2700 ELLIOTT AVENUE  
**JOSEPH ARNOLD LOFTS**  
DESIGN REVIEW RECOMMENDATION MEETING #2

DPD NO.3009932

JUNE 28, 2011

### INITIAL RECOMMENDATION OF THE DOWNTOWN DESIGN REVIEW BOARD

## Sight Distance and Relationships

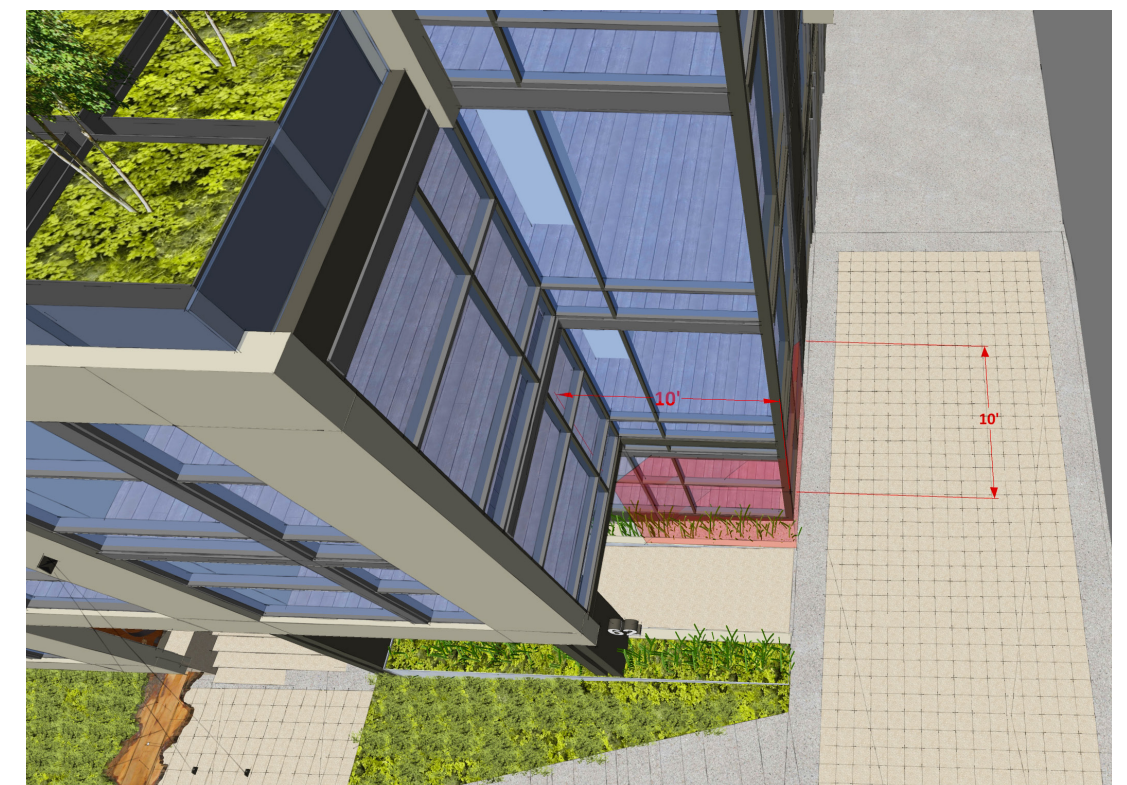
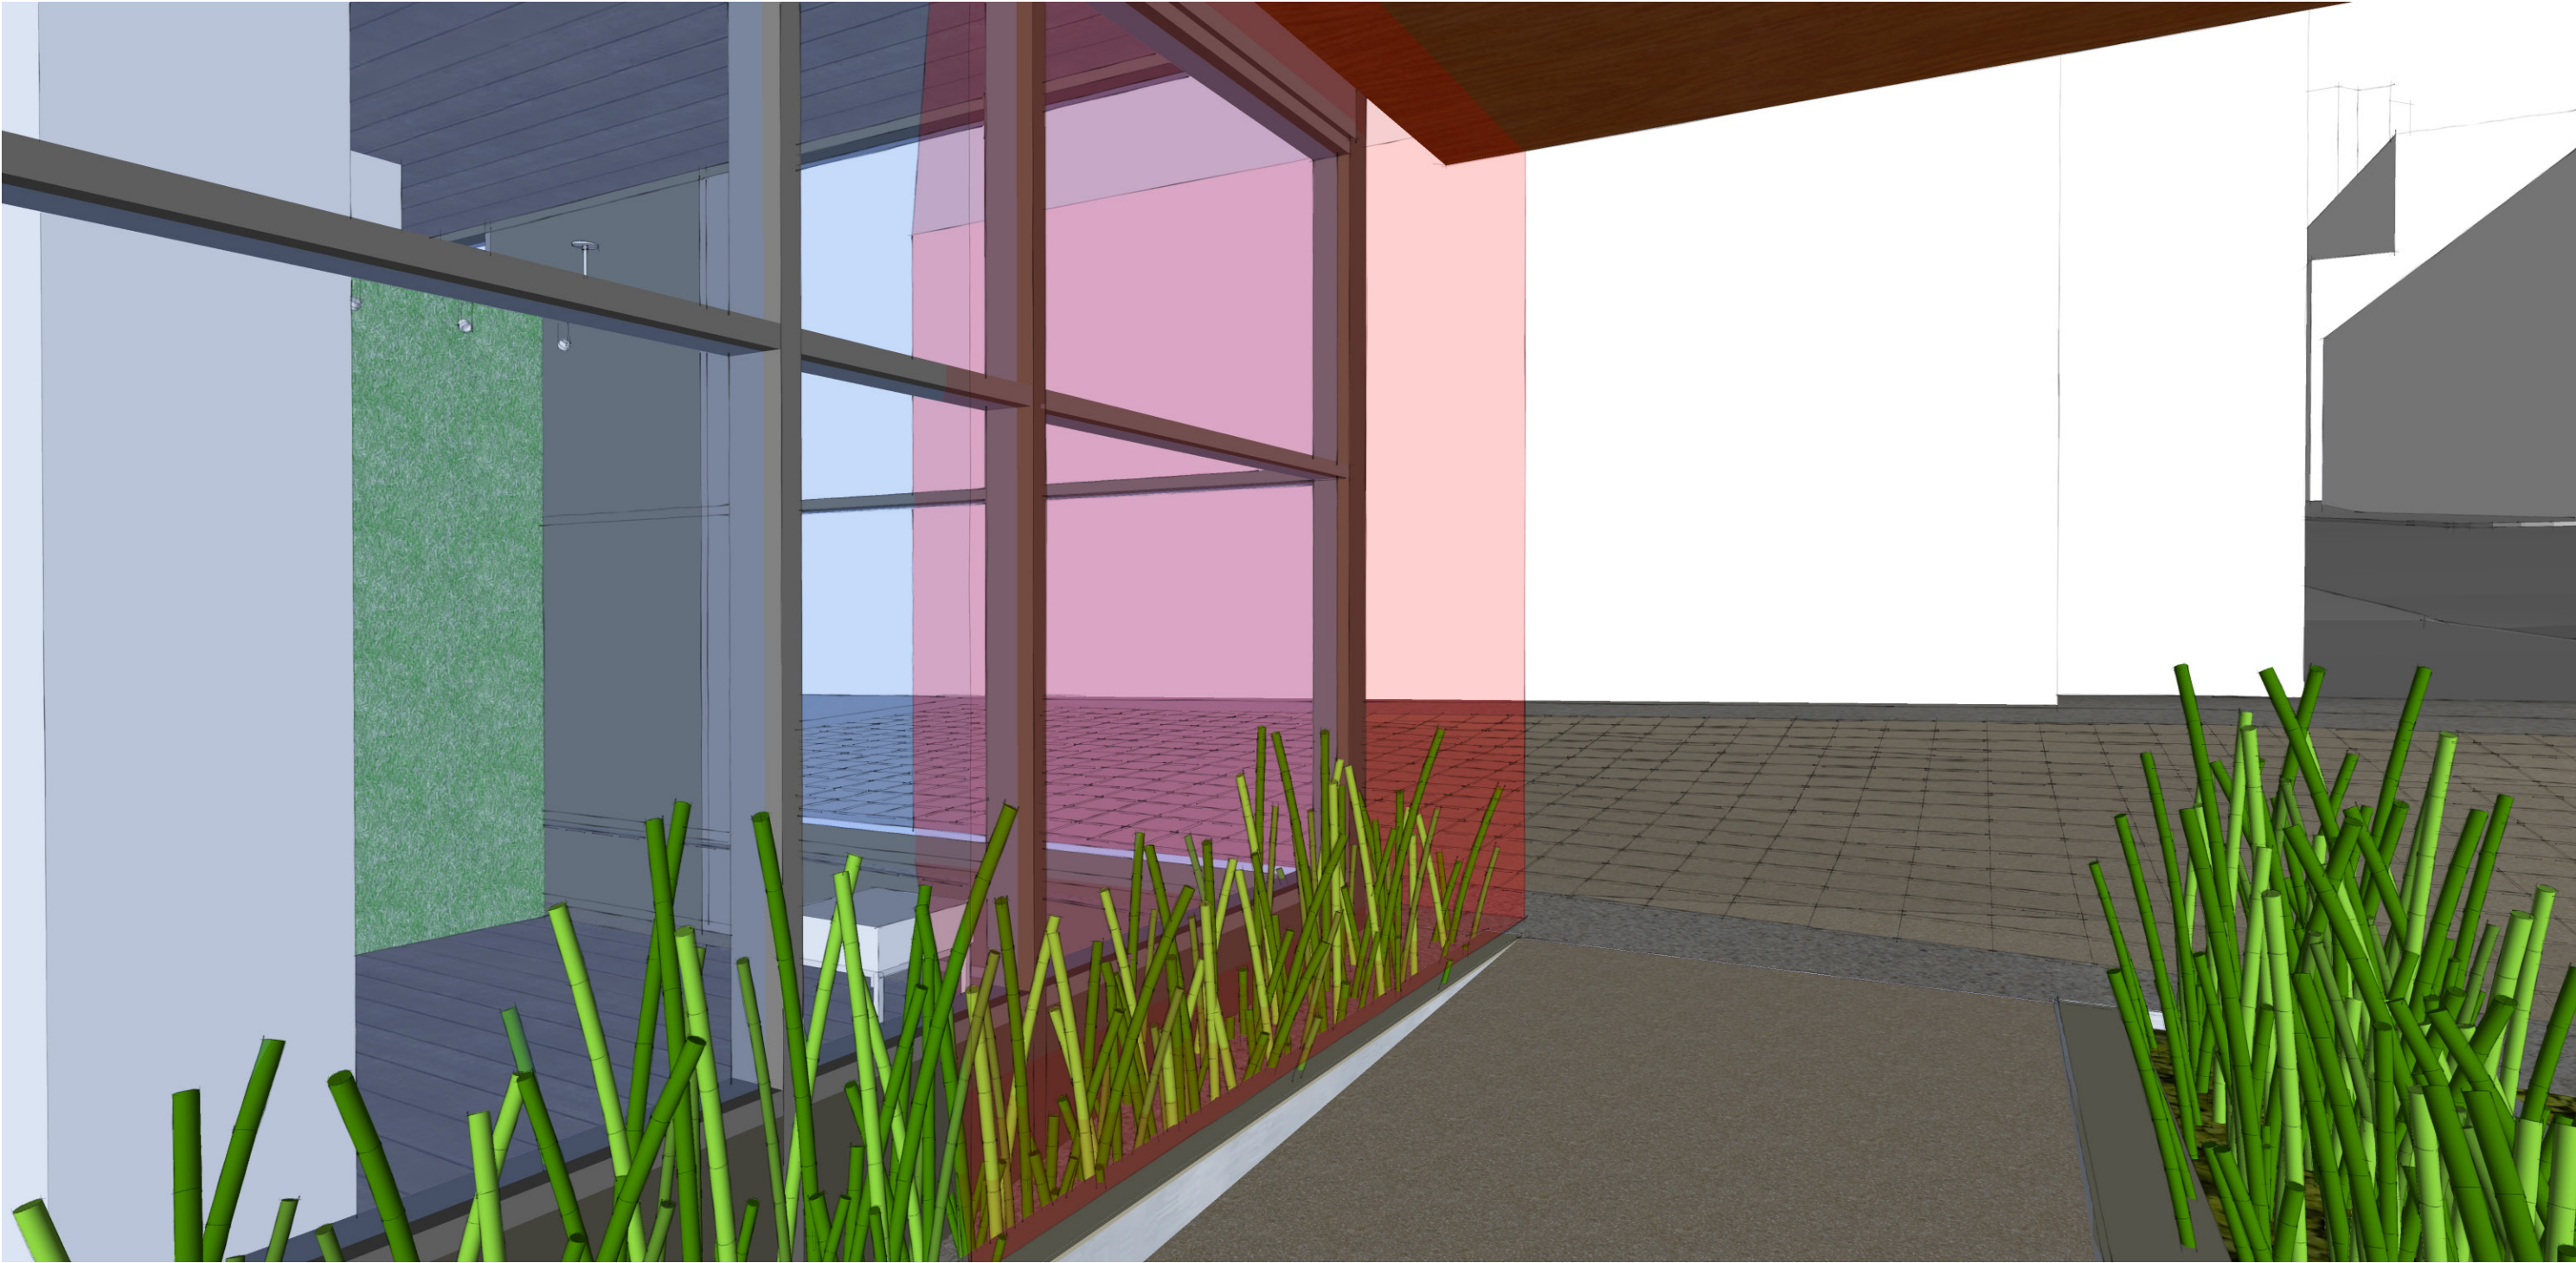
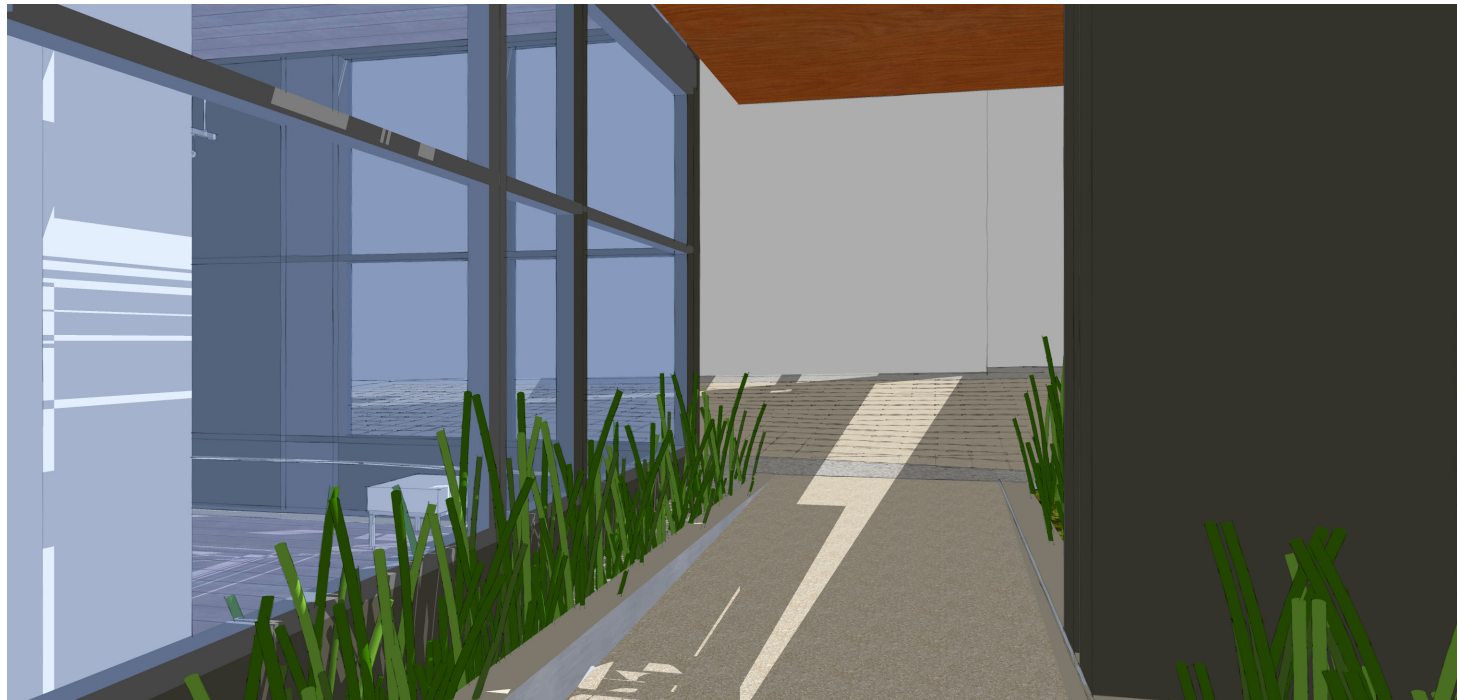
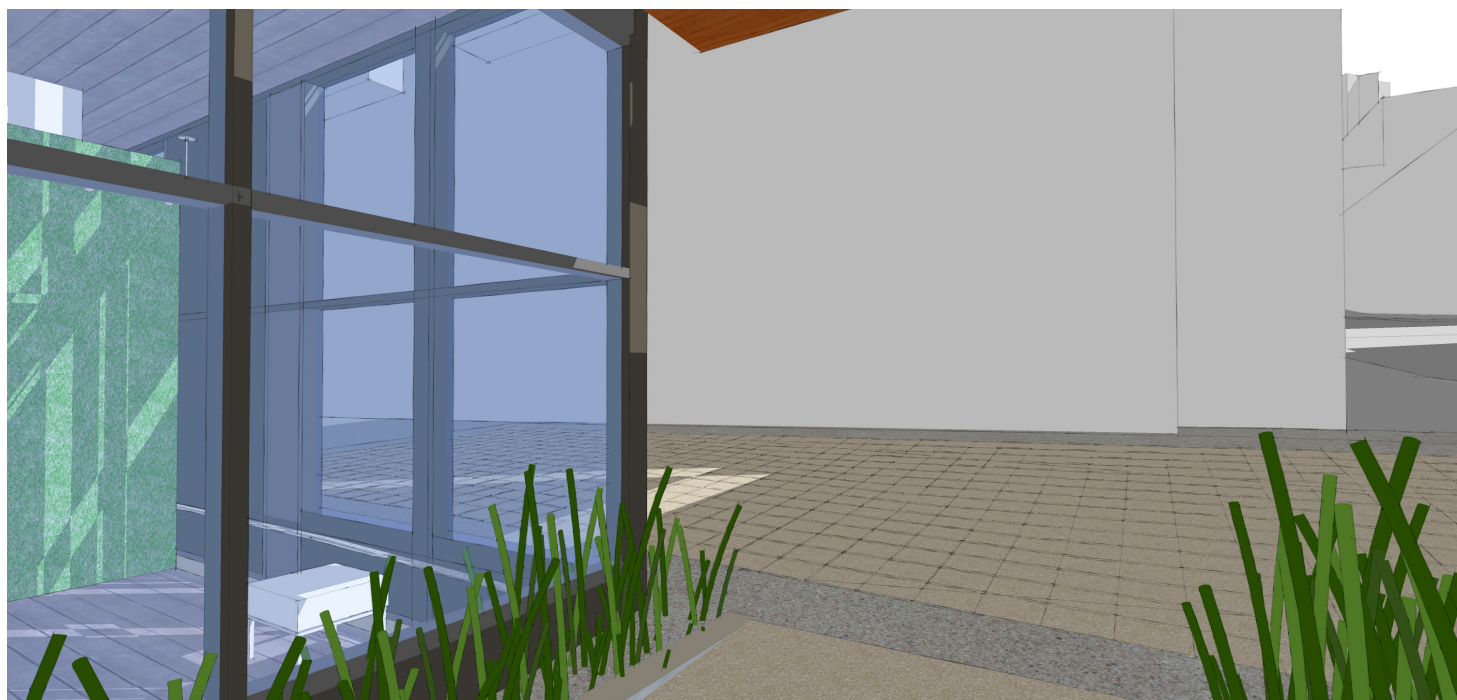
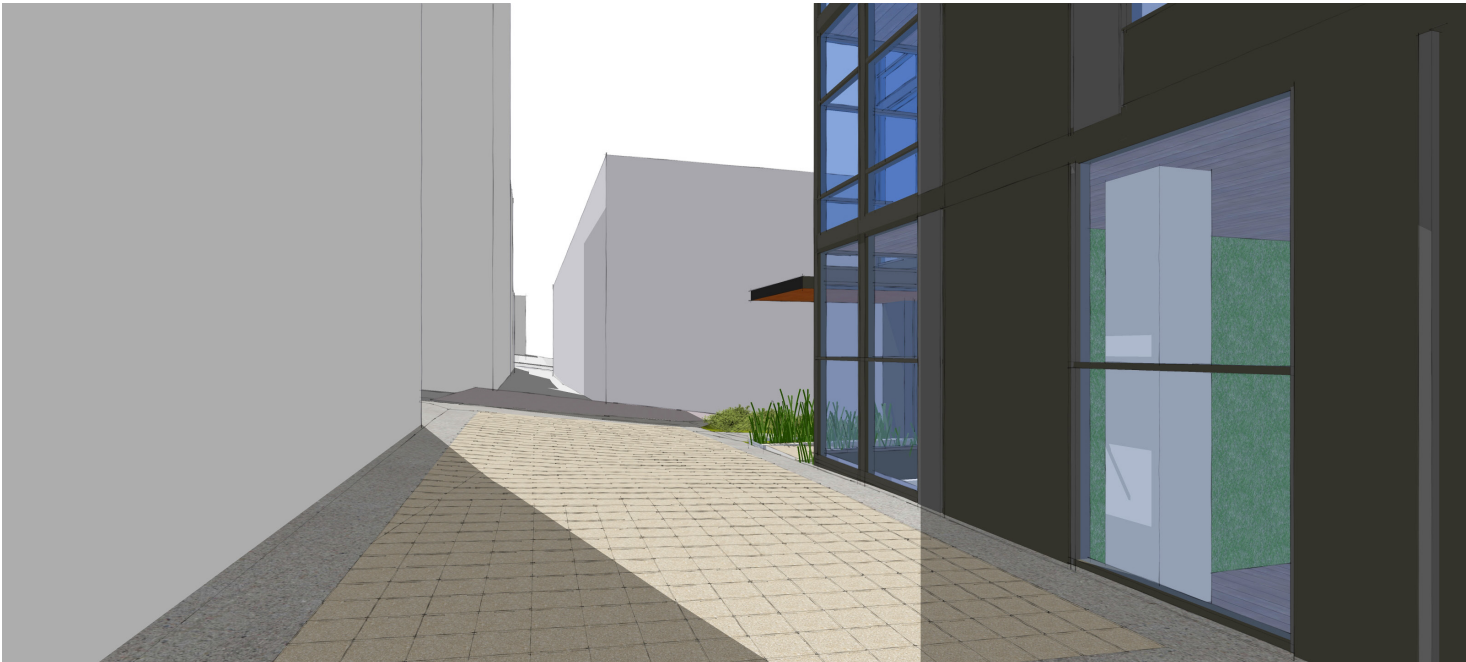
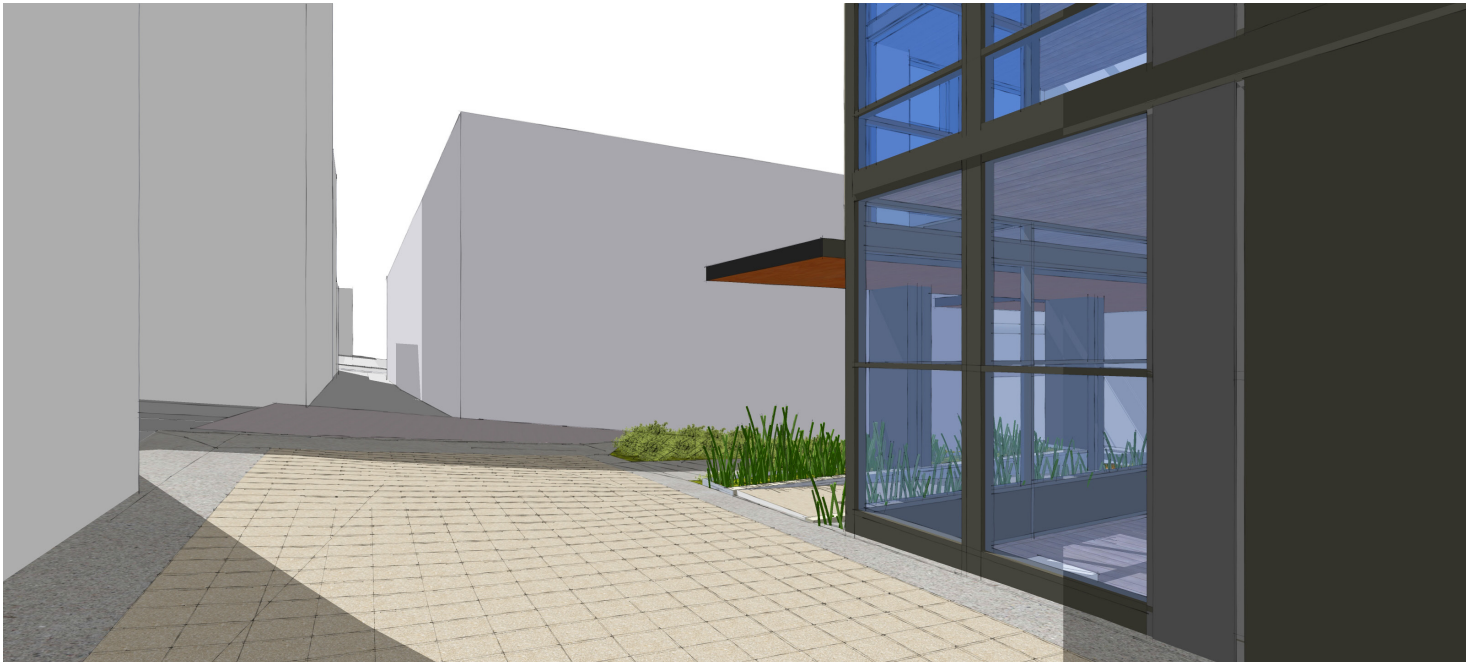
- Is the landscape near the pedestrian entry a forest or a grove? What is the landscape design intent there?
- The pedestrian entry point at the corner of Cedar St. and the alley could pose a safety issue as there is much traffic and there may be a tendency to stop or slow at the sidewalk, not at a building entry point accessing the alley north of the property corner and sidewalk.

The relationship between the alley and the building, especially the pedestrian entry element, caused the Board some concern over the interaction of pedestrians and automobiles. It requested that further work be done on this element, especially on ways to insure pedestrian safety exiting the building.

The Seattle Land Use Code calls for a sight triangle of 10 feet in each direction at intersections of streets with alleys **over** 22 feet in width. While this is intended to facilitate visibility from moving vehicle to moving vehicle, and while this sight triangle is **not** required in this instance or at this intersection, it likely supports a higher standard of pedestrian safety here as well.

Experiential view illustrating visibility at and through this corner, both from a pedestrian on the ramp, and from a vehicle in the alley. Corner glazing, at the building lobby allows through-views and performance exceeding that of the sight triangle.

This view sequence also illustrates visibility at and through this corner, from the point-of-view of a pedestrian on the ramp. Corner glazing at the building lobby allows through-views and performance exceeding that of the sight triangle.

Experiential views from the alley, from the point of view of an approaching vehicle, further illustrate the effectiveness of the transparent corner in avoiding pedestrian/vehicle conflicts.
